RFT 26-031 Milton # 13 Elementary School and Child Care Facility

PROJECT NO. 22124
HOSSACK & ASSOCIATES ARCHITECTS

ADDENDUM NO. 4

Issued February 26, 2026

AD
100

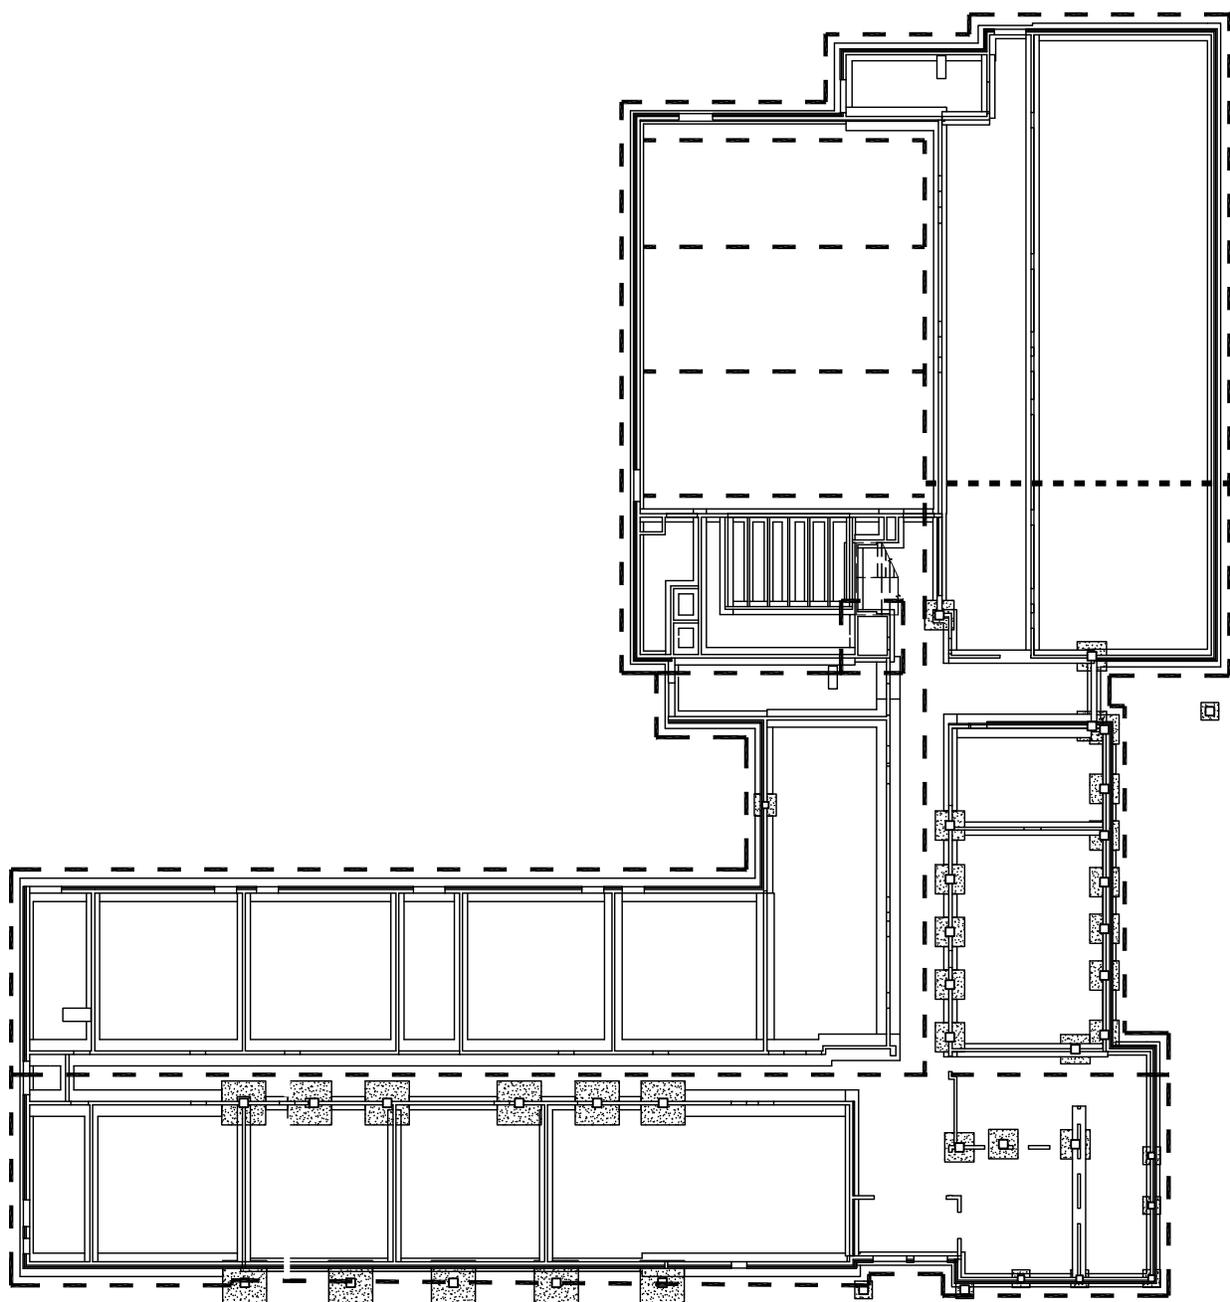
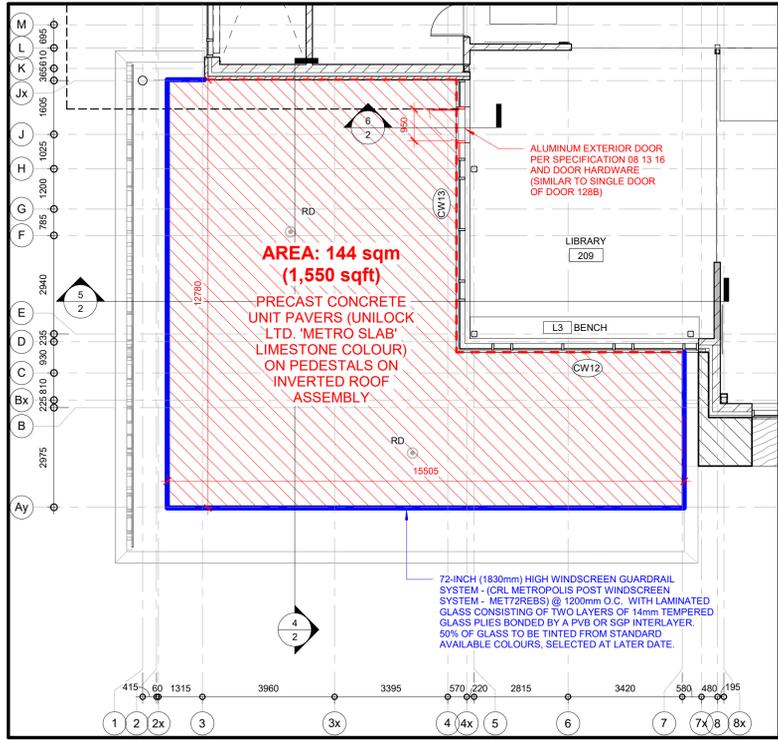
- .1 REPLACE: 'AD100' in its entirety with enclosed 'AD 100 Building Weeping Tile Location Plan' dated February 26, 2026.

Item 02: SKA-2 LIBRARY ROOF PATIO FOR ALTERNATE PRICE INFORMATION

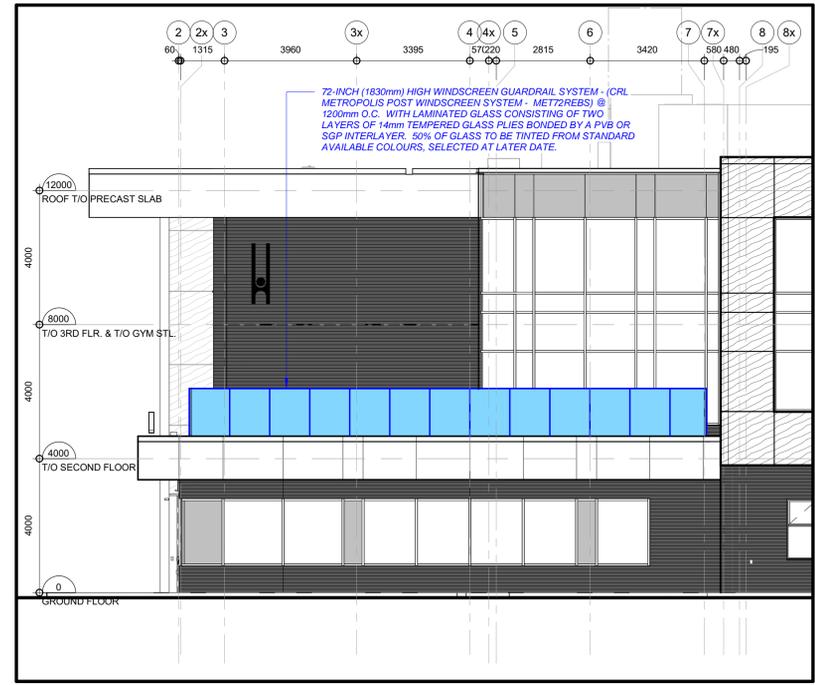
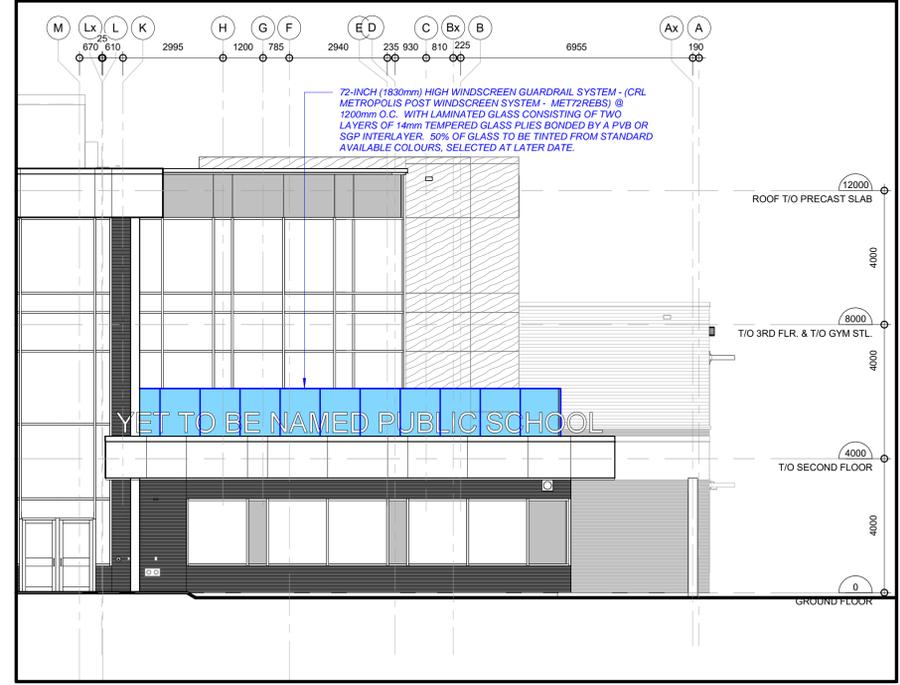
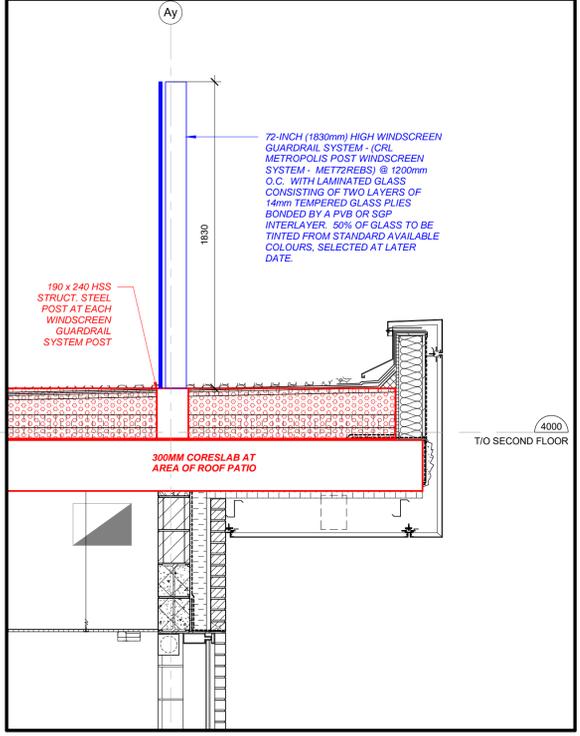
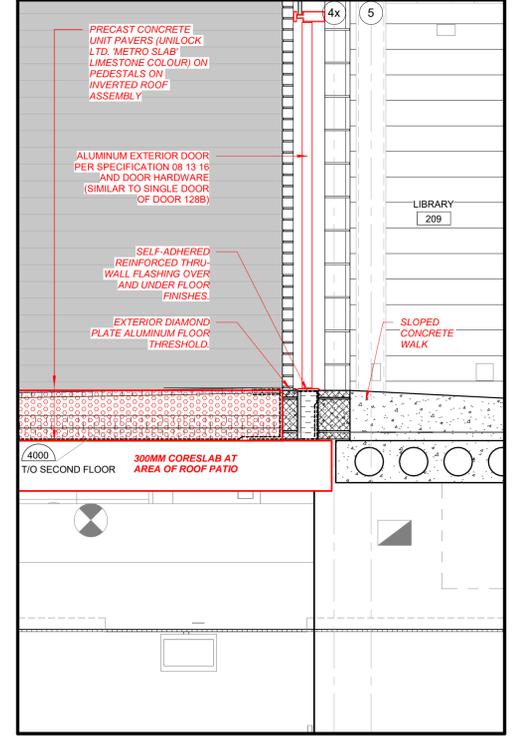
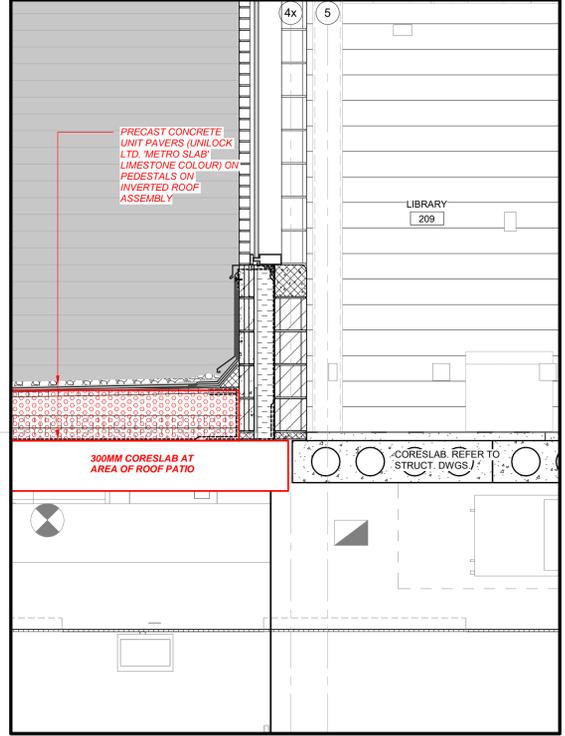
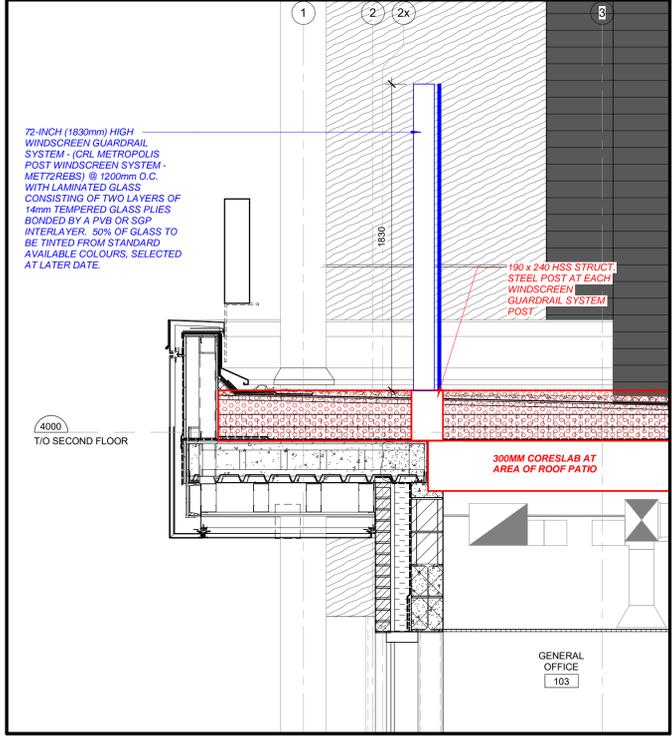
- .1 ADD 24" x 36" size drawing **SKA-2 'Library Roof Patio for Alternate Price Information'** to be used to provide alternate pricing information noted on 'Section 00 22 00 Supplementary Information Form', item 1.7.2 Alternate Price #2: Roof area to Roof Patio adjacent Library 209'.

DRAWING:
SITE SERVING PLAN

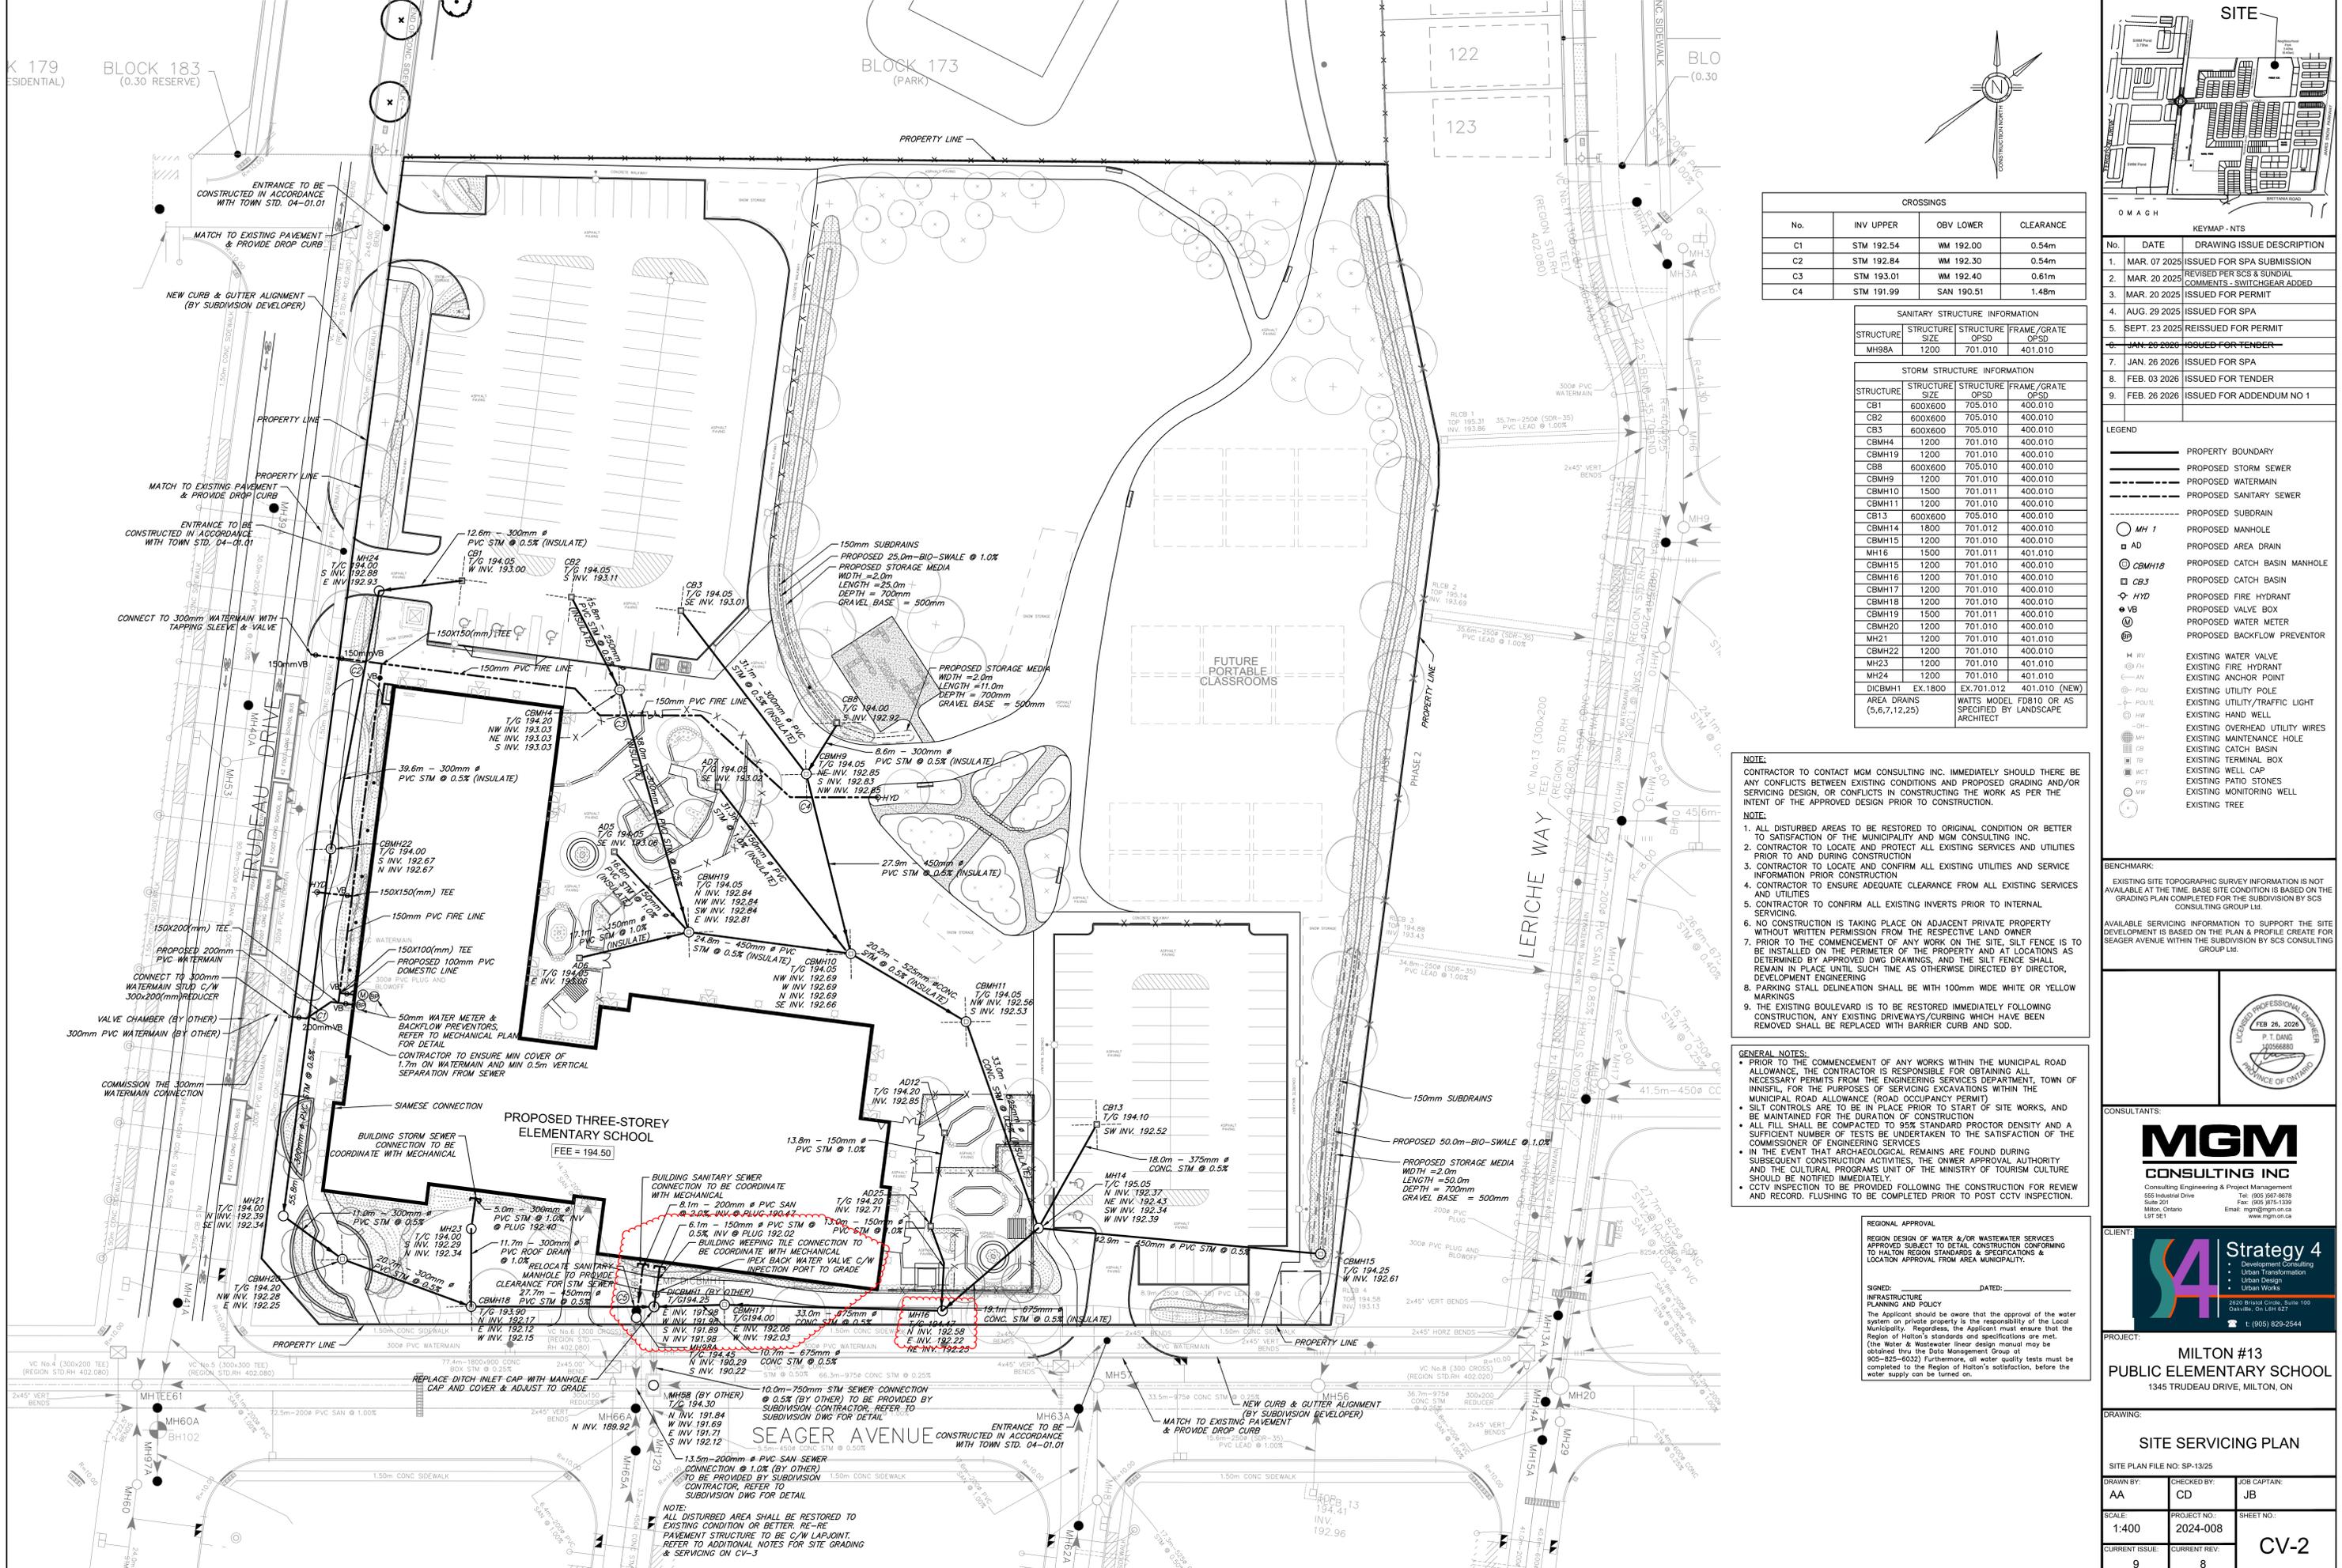
Changes to drawings CV2 has been made and highlighted on the reissued Civil package.
